**LEGAL ADVERTISEMENT
PORTLAND PLANNING BOARD MEETING**

Re: **February 9th Planning Board Workshop**
Level III Subdivision and Site Plan:
Redevelopment to create 4 residential units, 31 Fore Street
Bob and Carrie LeBlanc, Peninsula Property Development, Applicants

Bob and Carrie LeBlanc are requesting the Planning Board consider a Subdivision and Site Plan application for a new four-unit residential building at 31 Fore Street, at the corner of Fore Street and Waterville Street in the R-6 zone. The proposal is to replace the existing three-unit building with a new structure that includes a lower level for covered parking for 6 vehicles, stormwater treatment in a raingarden, and landscape and sidewalk improvements.

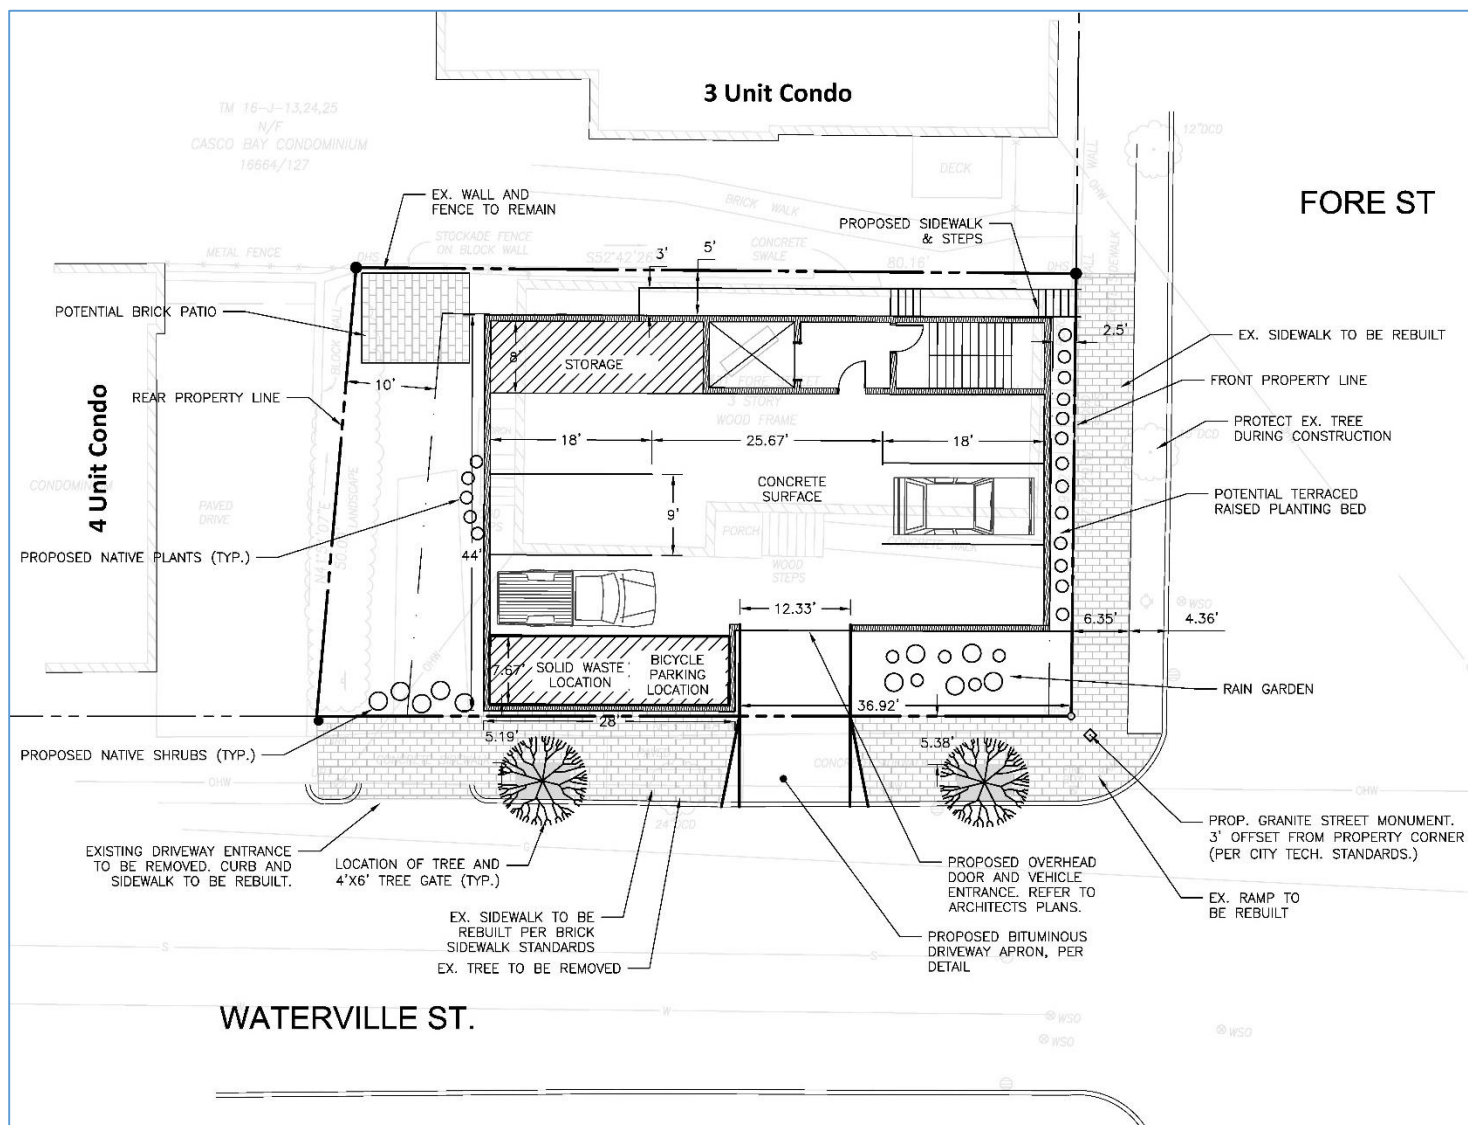
The hatched area on the plan below denotes the location of a second set of stairs which the applicant understands may be needed to meet building codes. This has been questioned by staff as it has implications for required setbacks as discussed below and in Sections VI A. *Zoning* and VI C 4. *Site Design Standards*.

The elevation shows a small stepback at the back corner on the basis that the hatched area on the plans will be largely taken up by a second set of stairs and that most of the elevation would be exempt from the stepback requirements. Staff are awaiting clarification from the applicant and building code reviewers as to whether the second set of stairs is required by building codes, as a longer section of stepbacked façade, with windows and other articulation, would be the preferred design to meet the objectives of the zoning requirement - see Section VI A. *Zoning* below.

The area for the second set of stairs is shown hatched on the floor plans (Plan P8). Staff have questioned the need for a second set of stairs (between the elevator and the rear wall) as this affects whether the project is compliant with zoning.

Assistant Fire Chief Keith Gautreau has confirmed (Attachment 2) that since the building is proposed to be sprinkled and is 4 stories or less, the Fire Codes allow a single means of egress and the second set of stairs is not required. However, under Building Codes the second set of stairs would be required if the building is considered to be 4 stories as defined in the IBC, and not required if the building is defined as 3 stories. The definition of a story relates to the extent to which it is below final grade and the applicant has been requested to provide the relevant calculations in order to establish the number of stories.
